SYSTEM 80+ ALWR

A PRA-BASED SEISMIC MARGIN EVALUATION

ADDITIONAL CLARIFICATIONS IN RESPONSE TO
NRC REQUESTED ITEMS

ABB Combustion Engineering

FIGURE 3.1: CMS3 Spectral Shape anchored to both 0.3g (Design Basis) and 0.6g (RLE), 5% Damped

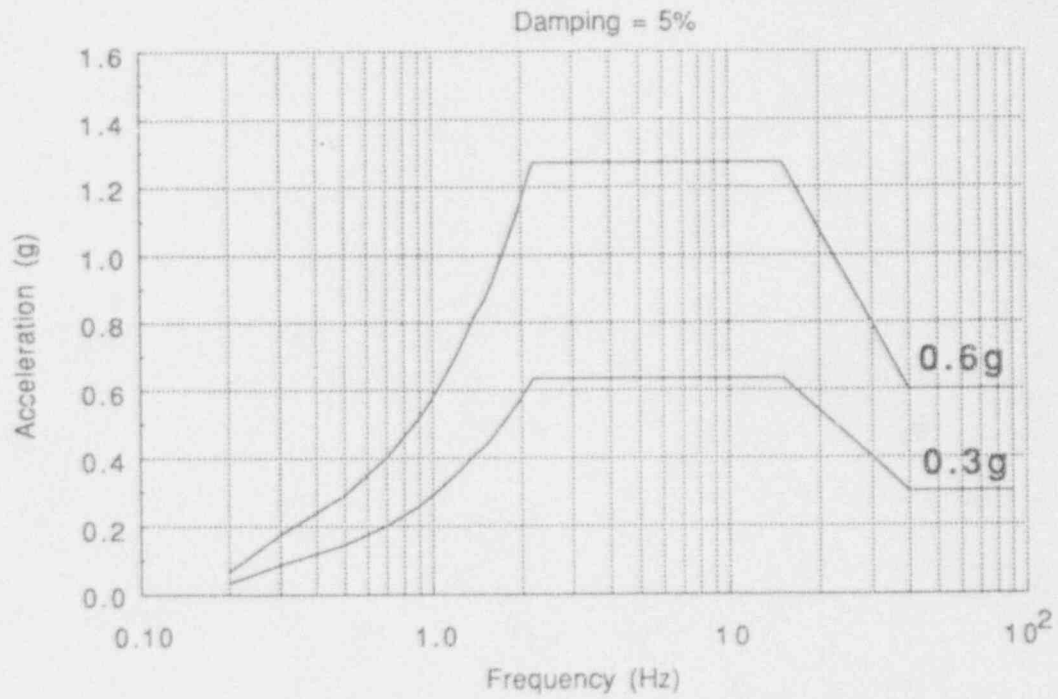
NRC REQUEST: Provide justification for selection of spectral shape to be used in the margin evaluation

Control Motion Spectrum 3 (CMS3) is a modified NUREG 0098 spectral shape. The modification is done by extending the flat portion of the spectrum from 8 Hz to 15 Hz in order to introduce more high frequency content typical of what might be expected from an Eastern U.S. earthquake. This spectrum is shown in figure 3.1 anchored to a PGA of 0.3g. CMS3 is one of the 3 control motions used in the design of System 80+.

Therefore, it is concluded that in order to meet the intent of the margin evaluation philosophy, the demand is to be defined as 84% NEP consistently at all frequencies. By choosing a NUREG 0098 spectral shape (representing 50% NEP) anchored to a PGA of 0.6g (representing 84% NEP) one arrives at an approximate 84% NEP RLE at all frequencies.

Figure 4.1: Comparison of Example Design Basis Spectra with CMS3 Raw Spectra for Both Design Basis and RLE and a Typical Individual Soil Case Response Spectrum (Elev. +50', Top of Basemat, E-W Direction, 5% Damped)

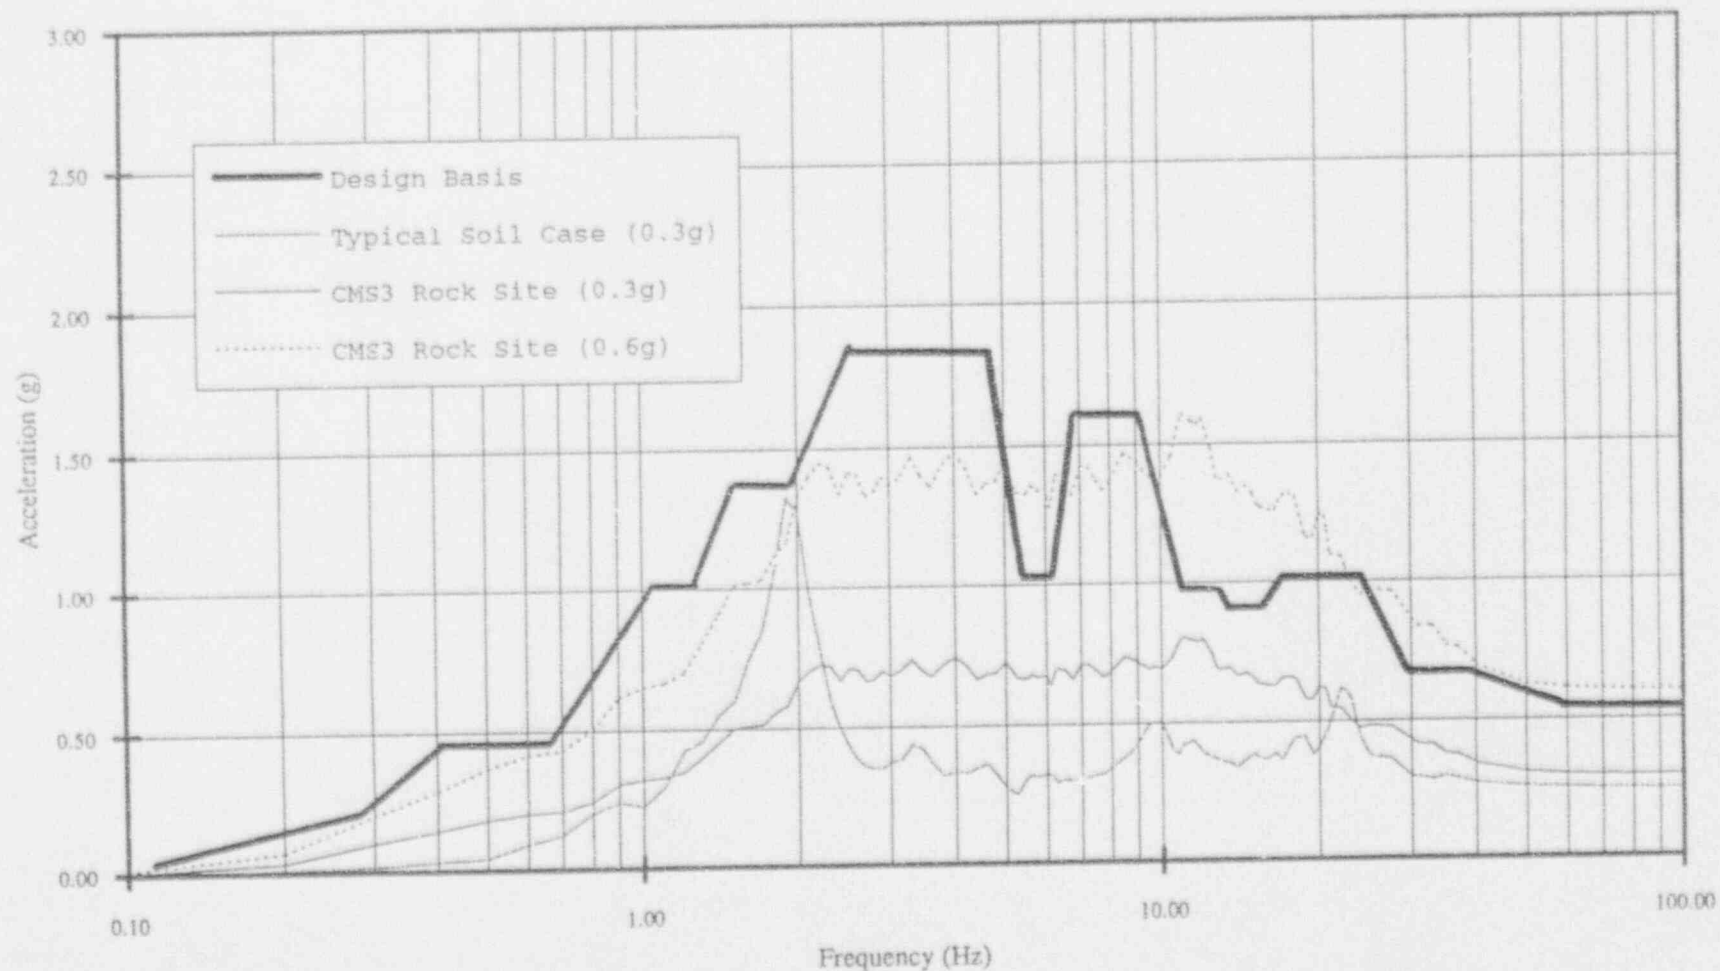
NRC REQUEST: Provide a position regarding applicability of the margin evaluation insights to soil conditions as well as rock conditions

The initial margin evaluation corresponding to rock conditions, is expected to result in HCLPF values in the range of 0.7g to 0.8g or higher (probably in excess of the desired HCLPF level of 0.6g). This is due to the observation that the System 80+ design basis spectra are fairly high (about 0.5g ZPA at foundation elevation). The high design basis spectra is primarily due to the convolution process associated with shallow soil sites when the control motion is defined at top of a hypothetical rock outcrop. Figure 4.1 shows the design basis broadened spectra at foundation elevation superimposed with the design basis CMS3 rock spectrum as well as RLE CMS3 rock spectrum anchored to 0.6g. Included in the same plot are the results of one of the soil cases which contributes to the highest spectral peaks at some narrow frequency (about 2.0 Hz.).

For the initial margin evaluation, it is therefore desirable to have a broad-band input in order to cover a wide frequency band of interest. Any one soil site is liable to have spectral peaks in a narrow frequency range, because of filtering effects associated with SSI phenomenon (e.g. soil case shown in Figure 4.1).

Figure 5.1: Typical Fragility Curves

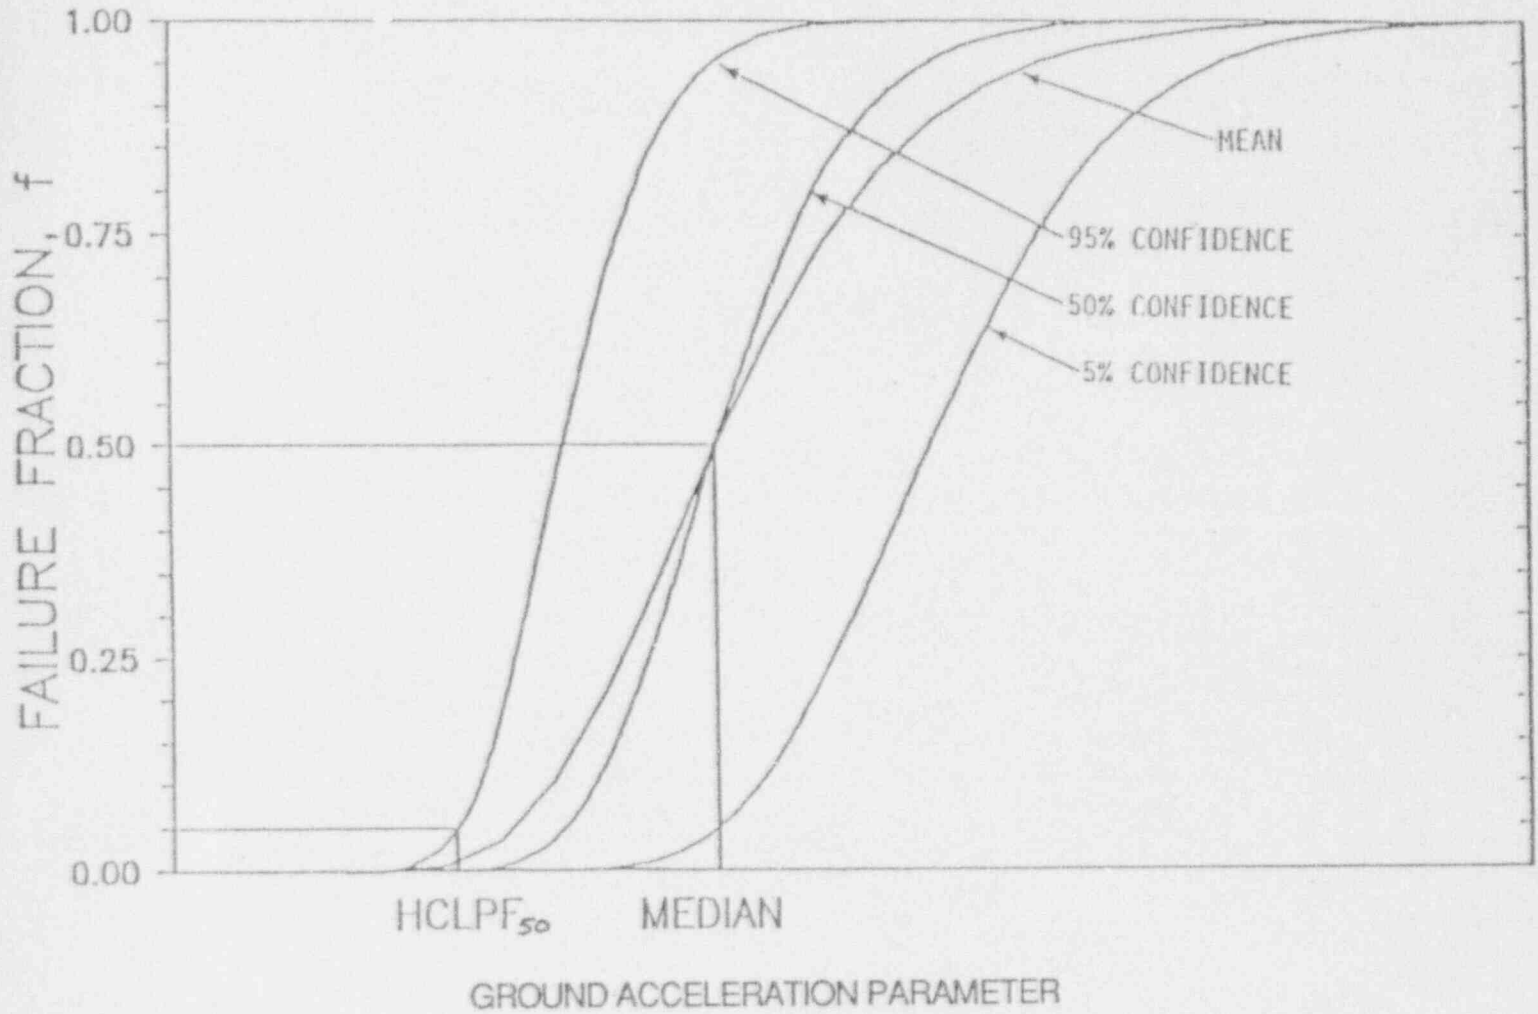
NRC REQUEST: Provide clarification on the notation of HCLPF₈₄ versus CDFM HCLPF

When one computes median fragility estimates, all parameters are assumed as median. This includes the definition of control motion meaning that at all frequencies of interest (if fragility is defined in terms of PGA), there is 50% NEP. In defining a family of fragility curves, one usually presents a number of curves ranging from 5% to 95% confidence level. On these plots, the acceleration level which represents the 5% probability of failure on a 95% confidence curve is denoted as HCLPF also. However, due to the definition of the input motion being 50% NEP, this HCLPF value is sometimes denoted as HCLPF₅₀ (see Figure 5.1).

The difference between this HCLPF₅₀ and HCLPF₈₄ as obtained from EPRI CDFM approach is purely due to the definition of the input motion, specifically whether it is defined at 50% NEP or 84% NEP. The relationship between these two HCLPF values is given as:
